# Changes to clause 95 to include TxVEC 'improved'

MMF ad hoc working document  
July 2014

## 95.7 PMD to MDI optical specifications for 100GBASE-SR4

Figure 95–3—TxVEC conformance test block diagram

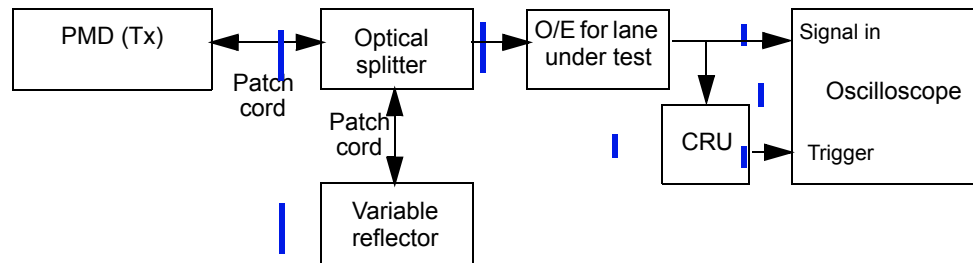
A block diagram for the TxVEC conformance test is shown in Figure 95–3. Other measurement

Each optical lane is tested individually with all other lanes in operation. The optical splitter and variable reflector are adjusted so that each transmitter is tested with an optical return loss of 12 dB.

The combination of the O/E and the oscilloscope used to measure the optical waveform has a fourth-order Bessel-Thomson filter response with a bandwidth of 12.6 GHz. Compensation may be made for any deviation from an ideal fourth-order Bessel-Thomson response.

The clock recovery unit (CRU) has a corner frequency of 10 MHz and a slope of 20 dB/decade.

**Figure 95-4—Illustration of the TxVEC measurement**

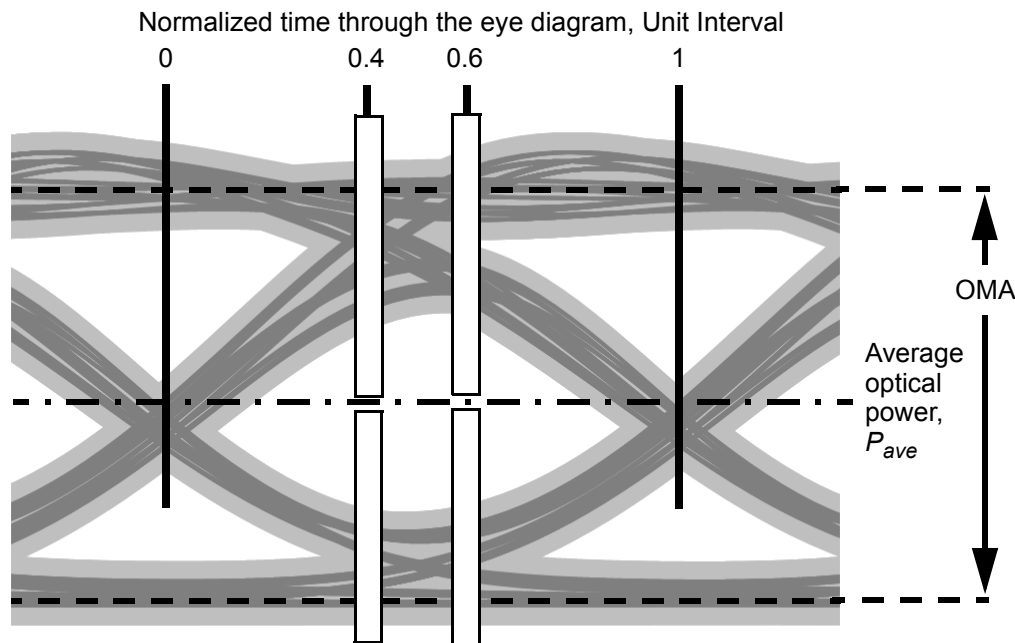
The oscilloscope is set up to accumulate samples of the optical eye diagram for the transmitter under test, as illustrated in Figure 95–4.

The average optical power ( $P_{ave}$ ) and the crossing points of the eye diagram, and the four vertical histograms used to calculate TxVEC, are measured using Pattern 3 or Pattern 5. The 0 UI and 1 UI crossing points are determined by the time average of the eye diagram crossing points, as measured at  $P_{ave}$ , as illustrated in Figure 95–4.

Four vertical histograms are measured through the eye diagram, centered at 0.4 UI and 0.6 UI, and above and below  $P_{ave}$ , as illustrated in Figure 95–4.

Each histogram window has a width of 0.04 UI. Each histogram window has an inner height boundary which is set close to  $P_{ave}$  (so that no further samples would be captured by moving it closer to  $P_{ave}$ ), and an

[outer height boundary which is set beyond the outer-most samples of the eye diagram, so that no further samples would be captured by increasing the outer boundary of the histogram.](#)
